Commissioner for Patents  
Page 3

IN THE DRAWINGS

Please amend FIG. 3 as indicated

REMARKS

Figure 3

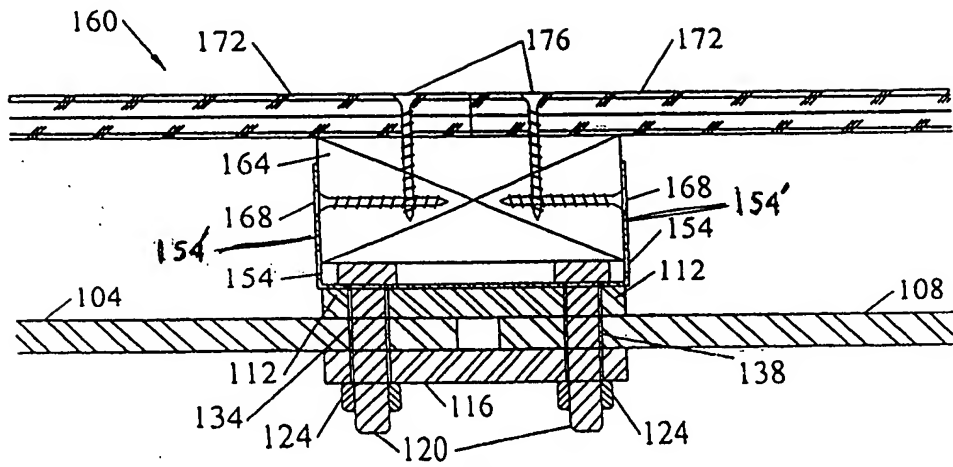
The Examiner indicated that he was unclear where FIG. 3 showed an arm, as an arm is not expressly discussed with respect to FIG. 3. Applicant noted that the application refers to U-shaped structures on several occasions as having arms and that one of ordinary skill in the art would appreciate that a U-shaped mounting bracket includes arms. See e.g. paragraphs 51, 52 and 67 and FIGs. 5 and 8b. Furthermore, Applicant noted that there is no requirement to discuss every structure with respect to every drawing of an invention. Doing so would result in applications which could be hundreds of pages long for even simple mechanical inventions. Furthermore, claim 22, specifically identifies the arm as being a part of the mounting bracket - which is shown in FIG. 3.

Applicant followed up the telephone interview with a written reply providing a detailed discussion regarding how FIG. 3 shows an arm which is connected to the facing strip. The Examiner has now issued a request for information asking that Applicant identify the specific element by number and discussion in the Specification. As Applicant has already indicated that the arm which is shown in FIG. 3 but not expressly discussed, the request seems redundant to what has already been discussed in detail between the Examiner and Applicant's counsel. To resolve the matter and return focus to examination of the claims, Applicant has amended the

specification and the drawing to clearly identify the at least one arm connected to the facing strip and extending away from the first piece of steel plate and the second piece of steel plate which is shown in FIG.3. The amendment to paragraph 41 and to FIG. 3 is clearly supported by FIG. 3 and claim 22 as originally filed. Thus, no new matter has been entered.

The arm 154' in FIG. 3 meets the limitation of cited language of Claim 21, as the arm , which is part of the mounting bracket 154 is attached to the facing strip 112 and extends away from the metal plates 104 and 108. This structure is also consistent with claim 22.
